Vermont Agency of Transportation
Reviewed by: M.H. MacKintosh
Date: May 20, 2014
☒ CONFORMING
☐ CONFORMING AS NOTED
☐ NON-CONFORMING - RESUBMIT

Temporary Shoring Submittal
April 14, 2014

Route 73 Bridge Project

Subject: Rochester ER BRF 0162(18) – Response to Comments – Temporary Shoring

Elevation View

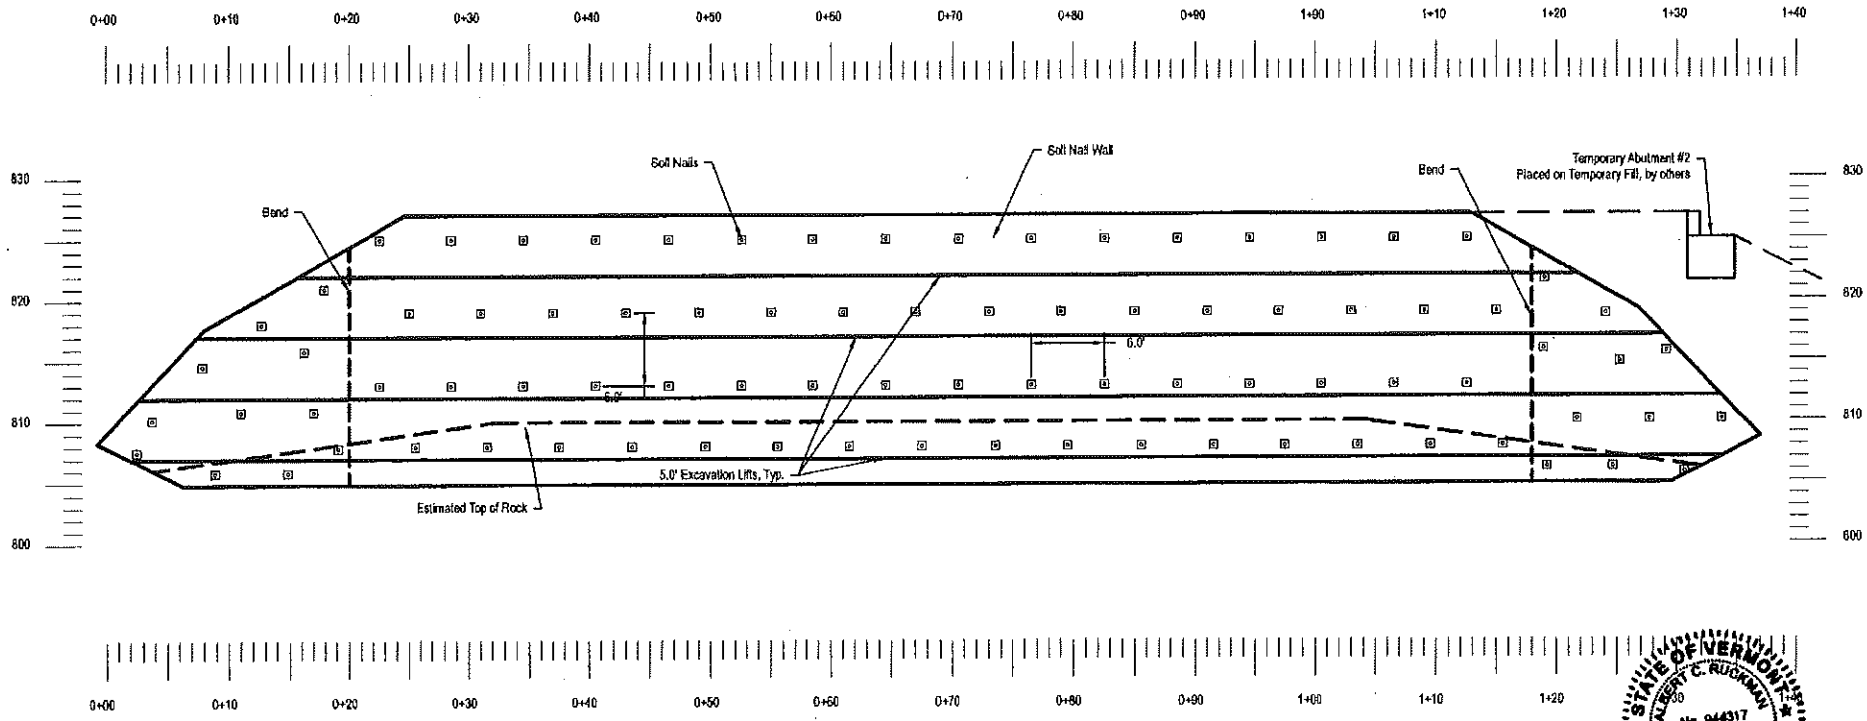
1. Sheets updated to show "Excavation will be conducted in a series of five (5) foot vertical lifts." Shown both on Sheet 2 (Notes) and Sheet 4 (Elevation View).

5. Plans have been updated to indicate a maximum vertical excavation of five (5) vertical feet prior to installation of nails (see response to comment 1, above). Also Sheet 2 has been updated to indicate the overall slope will be excavated approximately at a 12V: 1H or flatter.

Self–Drilling SuperNail® Detail

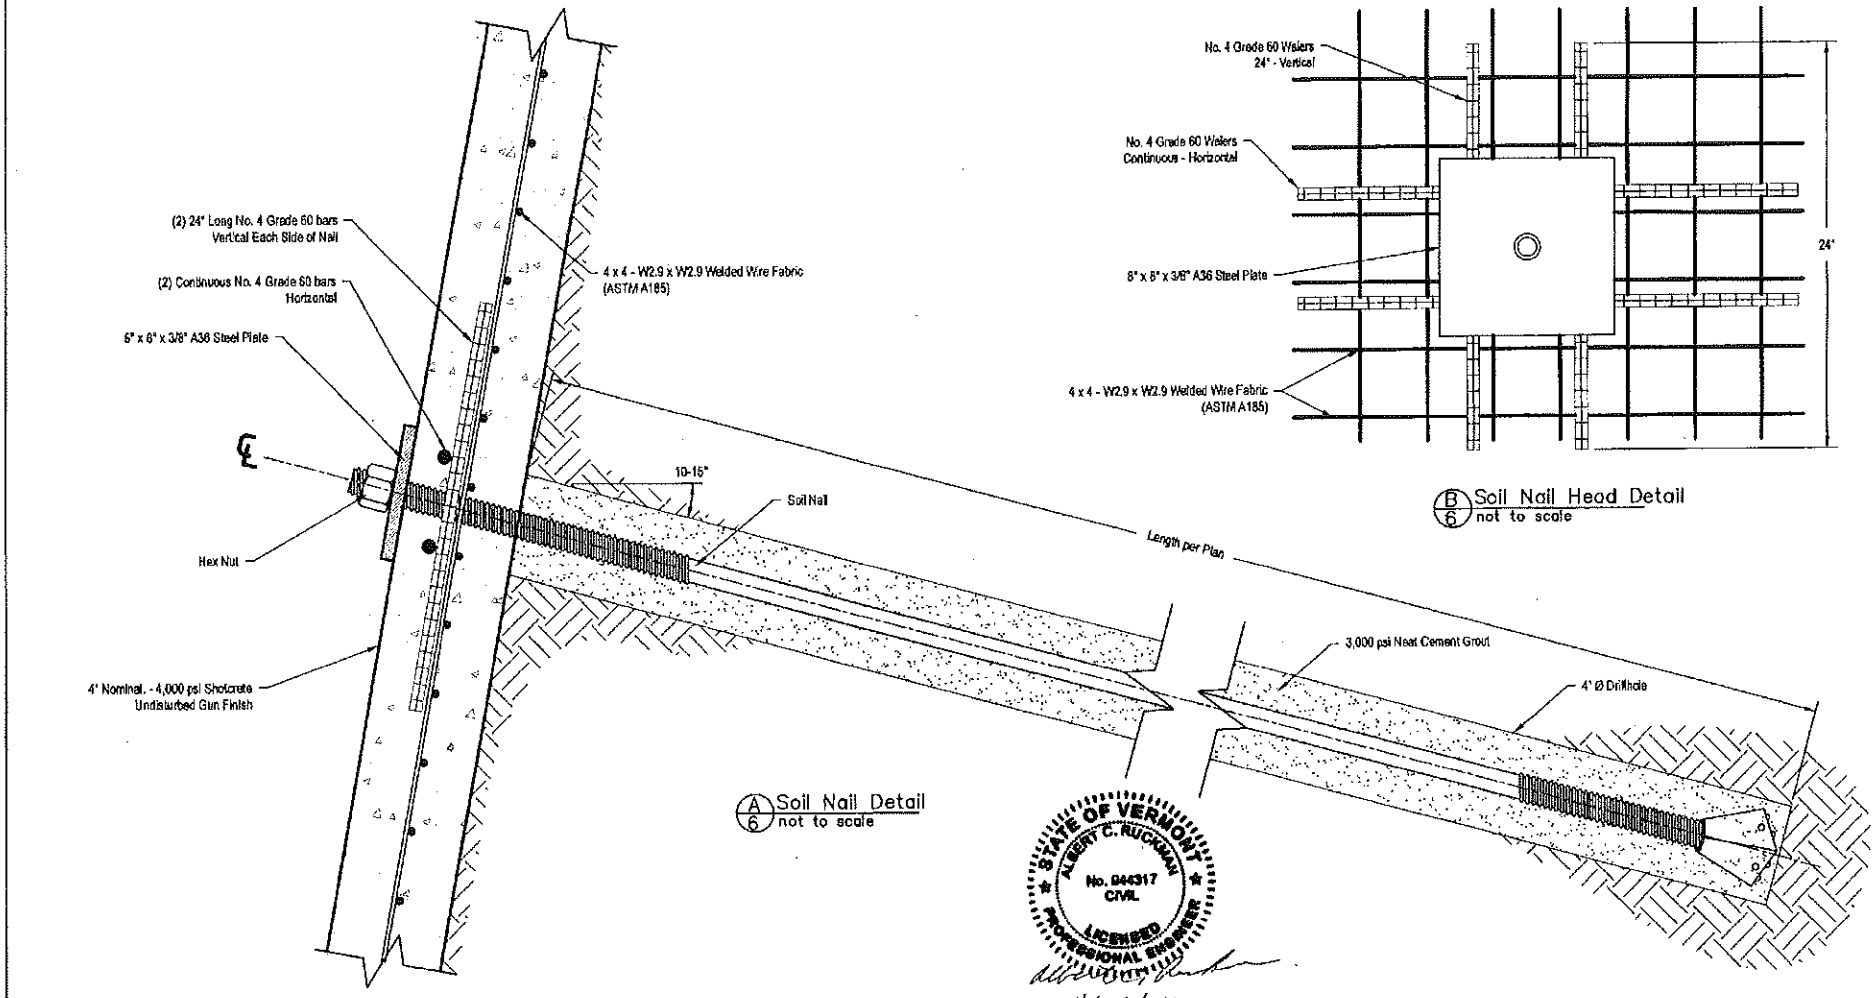
6. Plans have been updated and indicate preliminary lengths for soil nails of up to 19 feet, or a three (3) foot rock socket. A GSI engineer will determine final lengths based on field conditions and/or testing.

Test Nail Detail

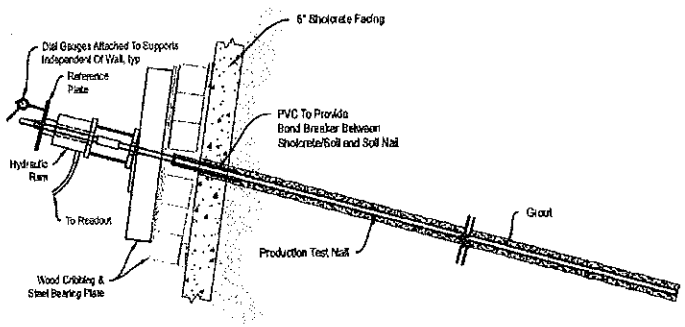
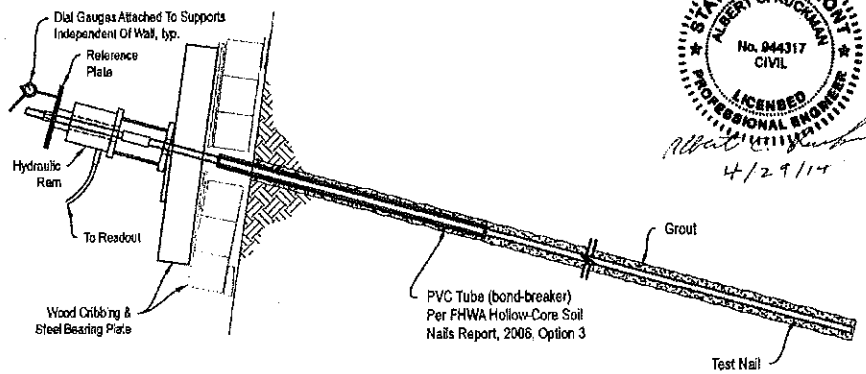
7. The design load has been incorporated in to the plan sheets.
8. The design plans have been updated to include a test nail sheet. A proof test will be conducted on one nail per row of production nails.

Project	Route 73 Bridge Replacement Project: Temporary Shoring
Analysis Description	Temporary Shoring
Drawn By	
Company	GeoStabilization International
Date	04/14/2014
File Name	VT 73 update.slm

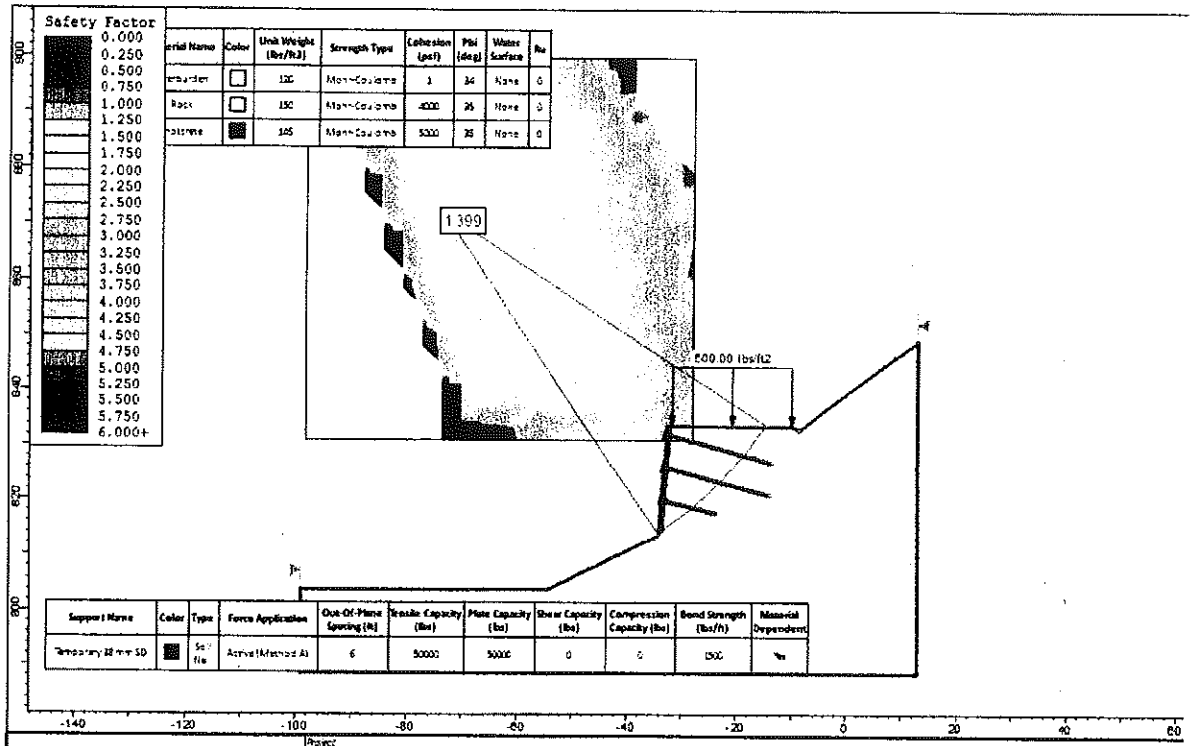
3. Additional loads have been placed on the temporary shoring structure to approximate reaction loads from the temporary bridge.
4. Calculations have been updated. Initial modelling used a surcharge load of 250 psf (equivalent of 2-ft of additional soil). The revised models shows a load equivalent to 2 feet of soil with an additional 2 feet of equivalent soil (total of 4 feet) to account for normal traffic loads, construction activities, and additional reaction loads from the temporary bridge.
